1916 EASTLAKE AVENUE E
RECOMMENDATION MEETING
NOVEMBER 15 2017
SDCI #3023368

EDG SUMMARY & RESPONSE

1 ROOF SIZE

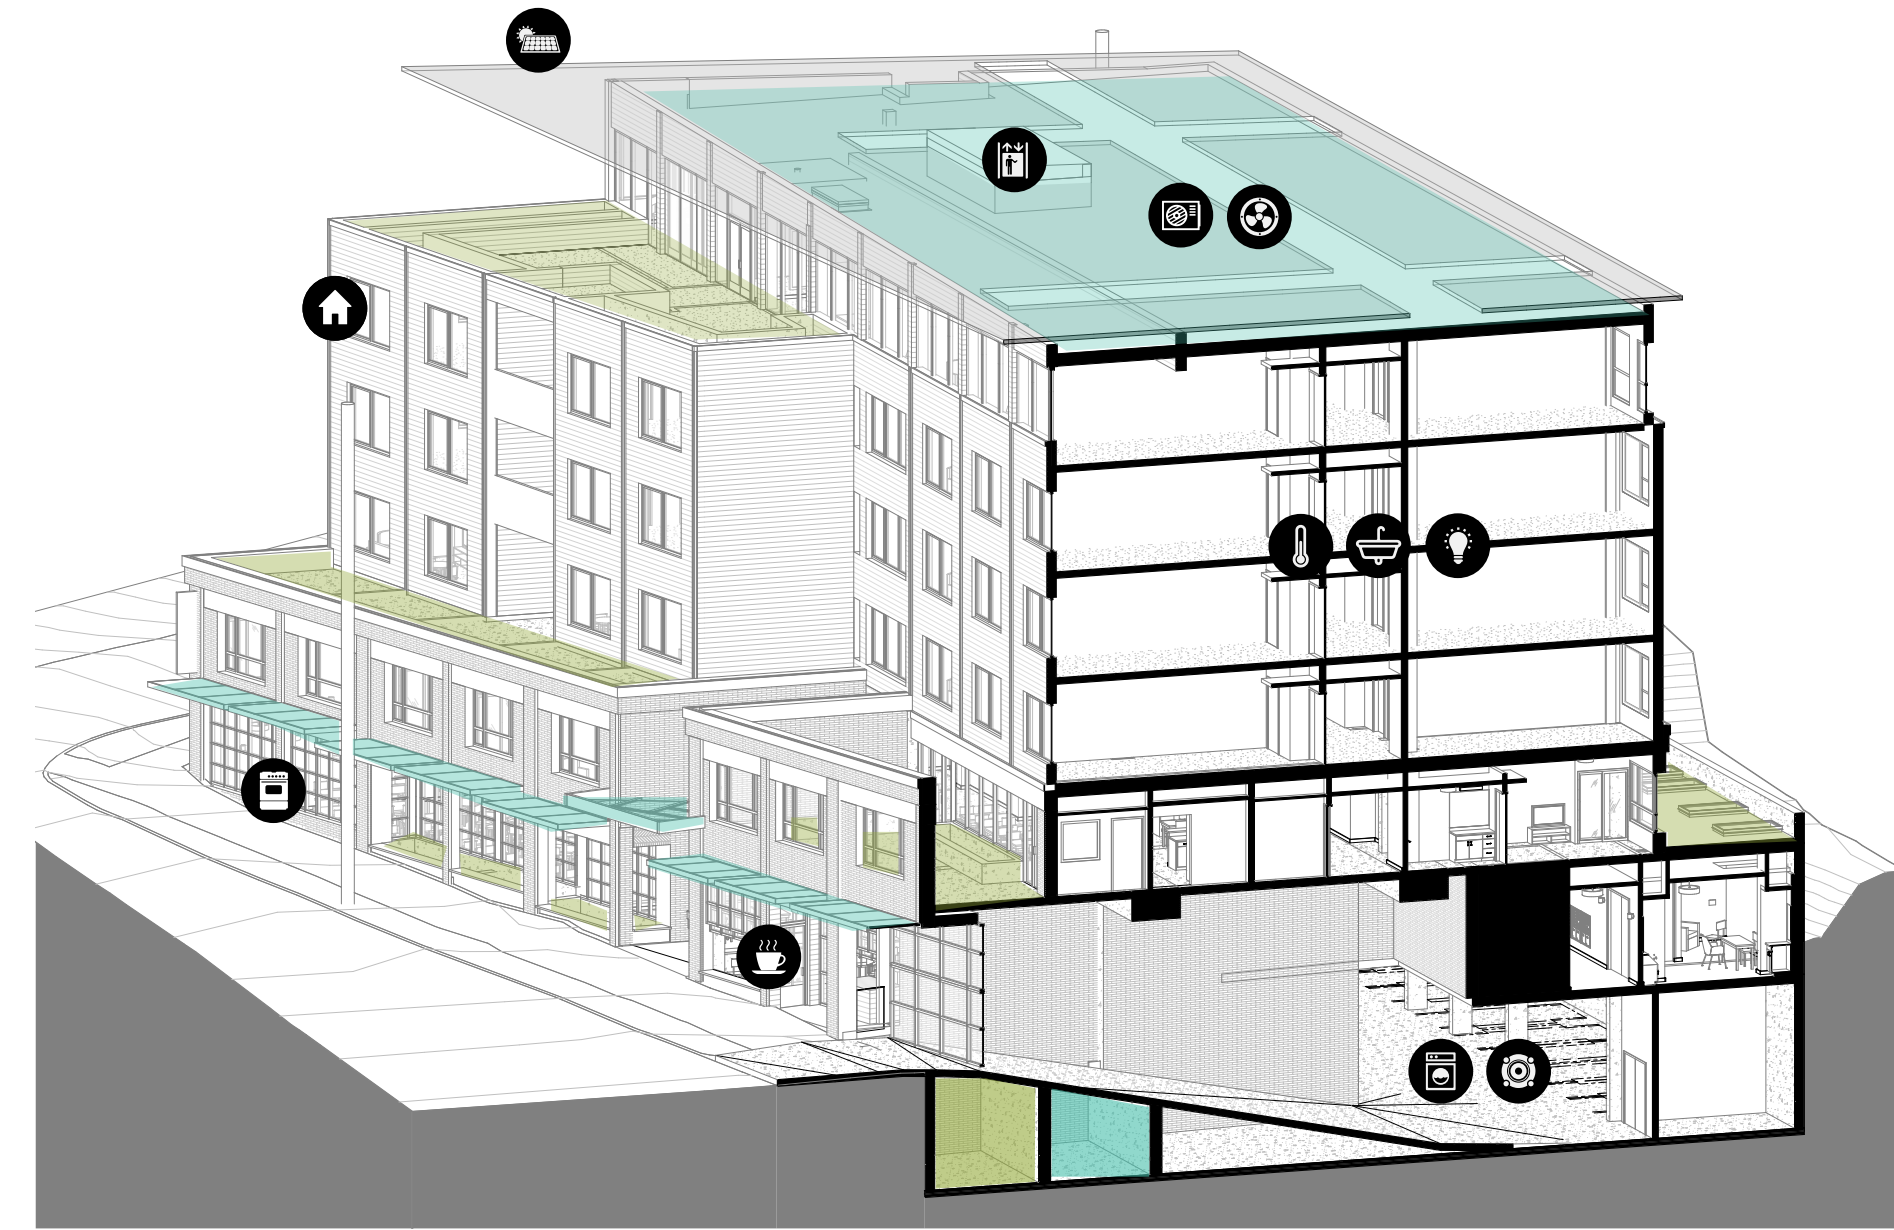
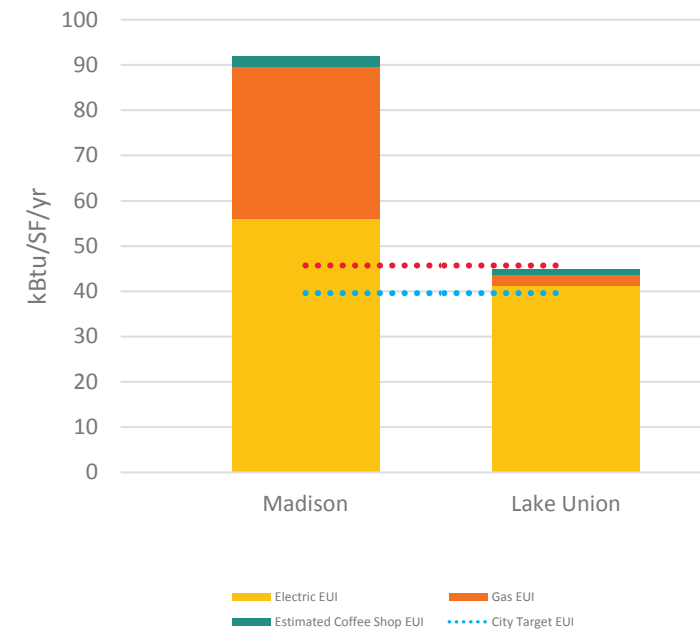
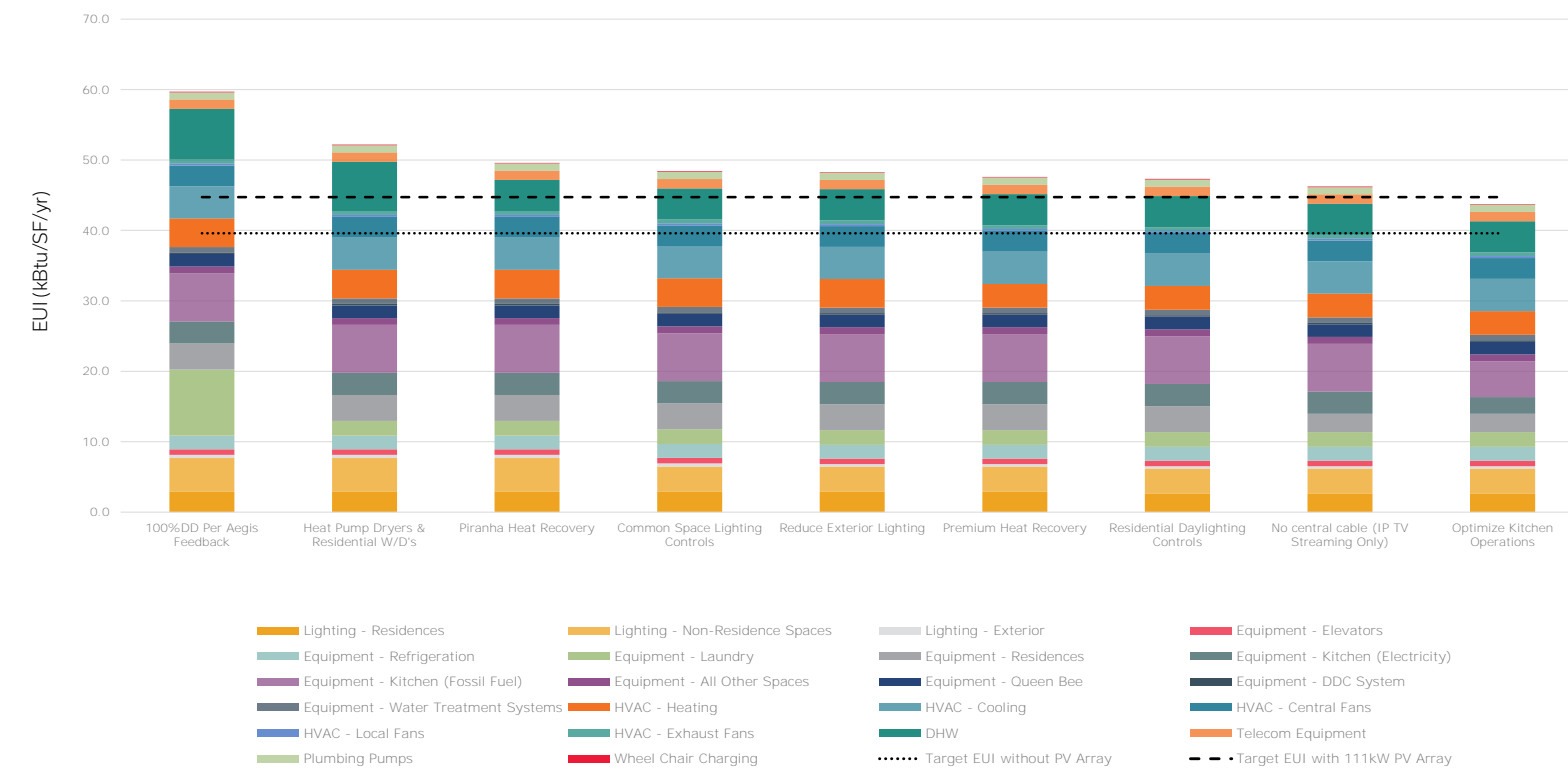
Echoing public comment, the Board expressed concern regarding the roof form, size, and location. At the Recommendation phase the Board would like to better understand the minimum roof size necessary to meet LBC requirements and that the application should research alternative energy strategies to minimize roof size (CS1-A, CS2-D).

2 ROOF FORM & LOCATION

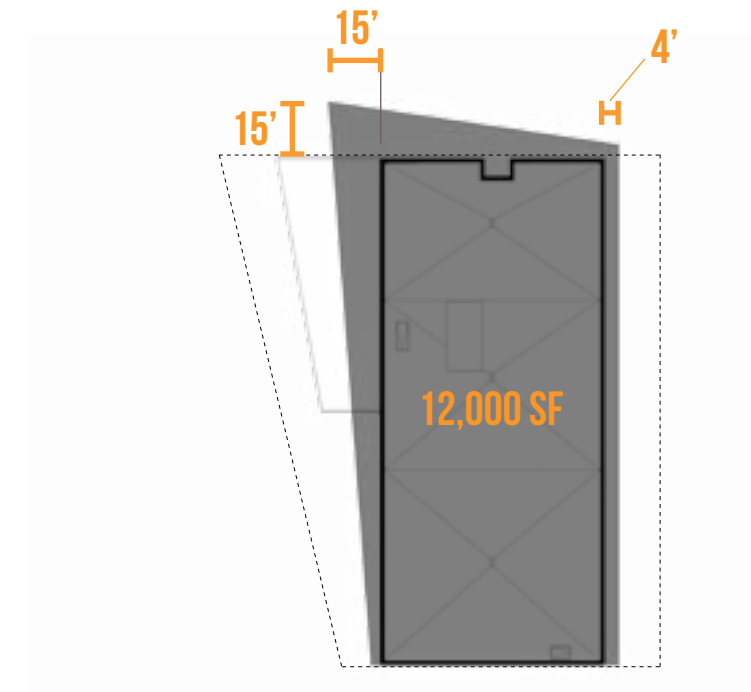
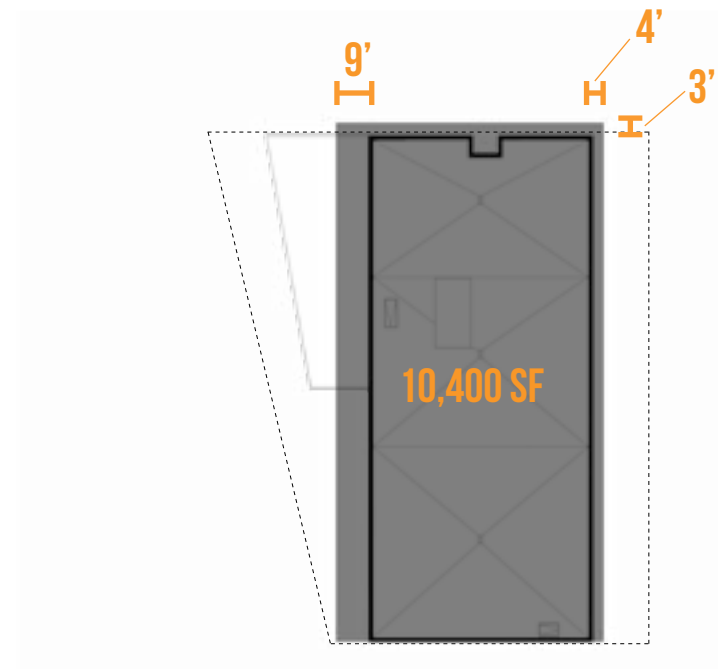
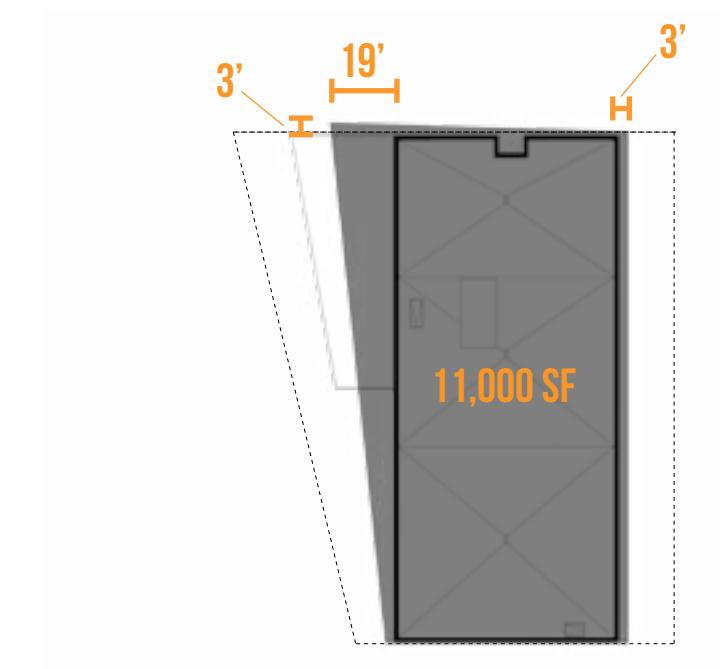
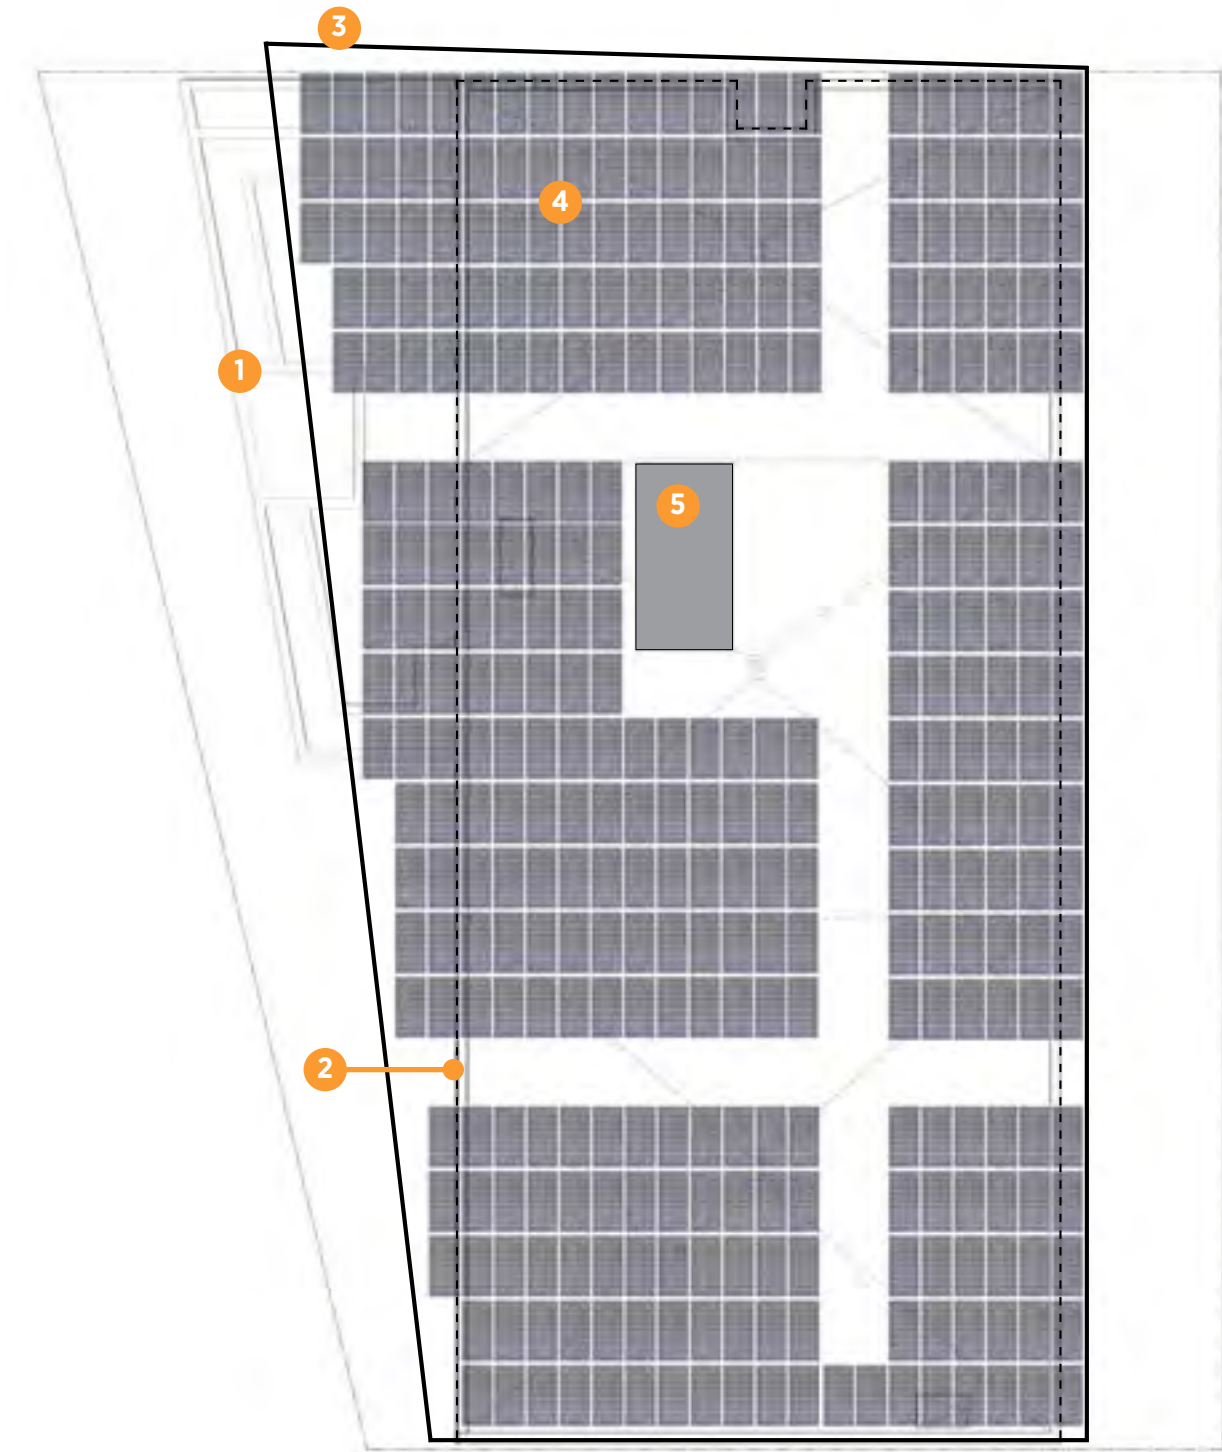
The Board supported the low point of the sloped roof to the east, adjacent to lowrise residential uses. In agreement with public comment, the Board noted that the roof elevation is a critical elevation and directed the applicant study the roof form and location to minimize impacts to the E Newton right-of-way and balance impacts across the site (CS1-A, CS2-D).

In response to EDG comments, the project team has studied form and location of the solar array. Once the team was able to minimize the area of the array to the extent possible (see 1a.), the team explored multiple massing options. We were able to minimize the overhang of the array into the E Newton St right-of-way by locating the bulk of the massing toward the urban street (Eastlake Avenue E) while maintaining the low point of the solar array toward the residential zone to the east.

- Further project development including more extensive engineering and introduction of increased Energy Conservation Measures reduced solar array area required to 10,000 square feet.
- Solar array overhang into E Newton Street right-of-way reduced from 10-foot to 3-foot and additional area required was concentrated toward the west, locating the buld of the massing toward the urban street (Eastlake Avenue E).
- The low point of the solar array was maintained at the east adjacent to existing residential units.
- Fascia was reduced to minimize the scale of the array.

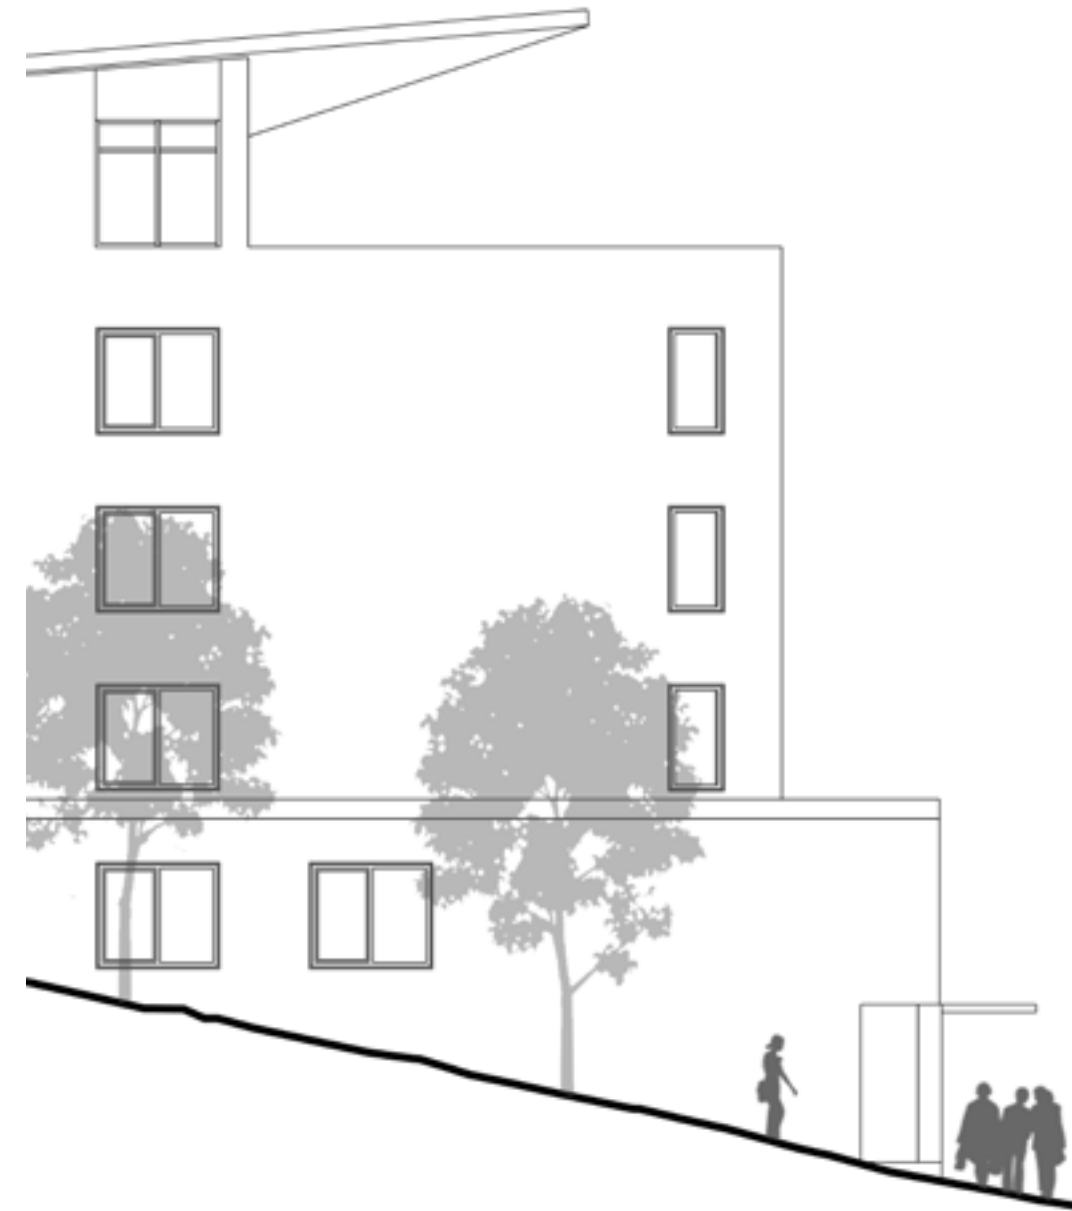
The Board expressed concern regarding the treatment of the Newton Avenue facade near the corner of Eastlake. At the Recommendation phase the Board would like to see additional fenestration, at all levels, composed to accentuate the corner of the building and along the Newton facade (CS2-C, PL3-C, DC2-C).

As asked by the Board at EDG, the project team has addressed the corner of Eastlake Ave E and E Newton St to accentuate the corner of the building. Due to the complex nature of the site - in particular, the 20% grade on E Newton St - and the goal to maintain privacy to the extent possible for the neighbor to the north, fenestration was not the appropriate response at all levels. In these cases, the project team integrated artwork and brick detailing to accentuate the corner.

- 1 Added more glazing at upper residential levels
- 2 Protected privacy of residents at memory care level
- 3 Added brick detail and planting for visual interest
- 4 Added glazing at corner
- 5 Added building info plaques where glazing not feasible
- 6 Pushed dining area further out toward corner
- 7 Enhanced brick detailing around corner at all sides
